REPORT

PROPOSED DORVAL DRIVE SUBWAY

memorandum

Re: Foundation Investigation Report
For
W.O. 82-26025
District 4, Hamilton
GO-ALRT, West Extension, Oakville Project
Dorval Drive Subway

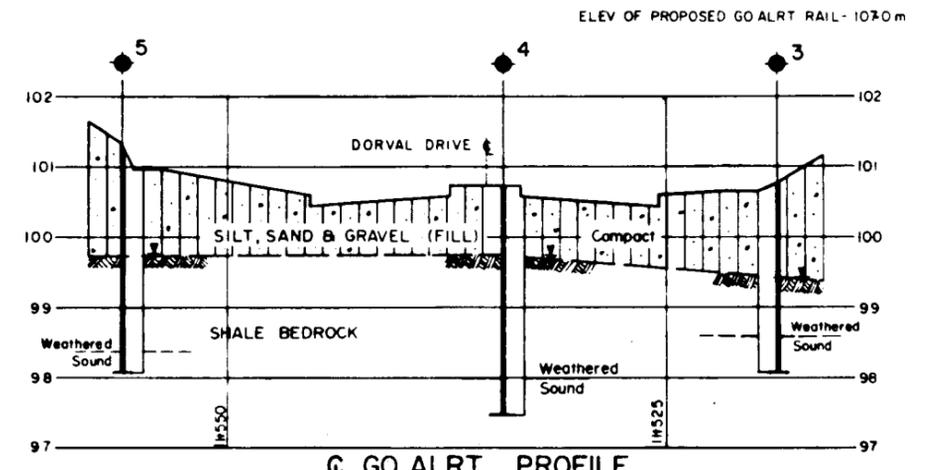
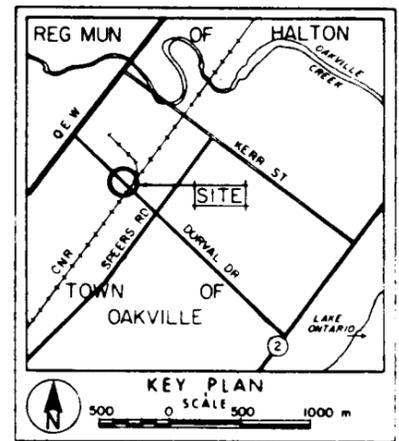
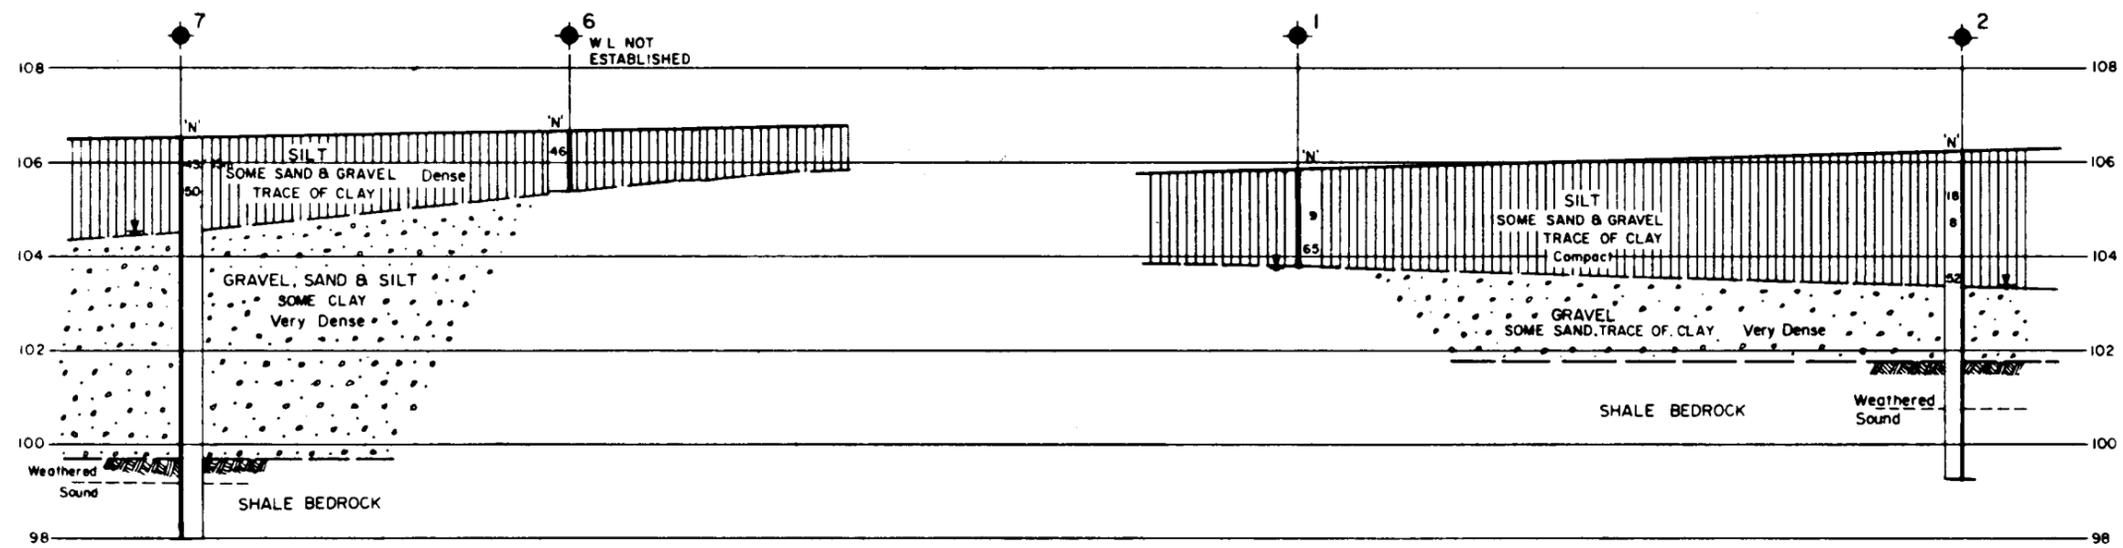
The factual information (Sections 1 - 6 & Record of Borehole Sheets & Borehole Locations/Soil Strata Drawing) within the consultant's report is considered to be acceptable for the purpose of this project.
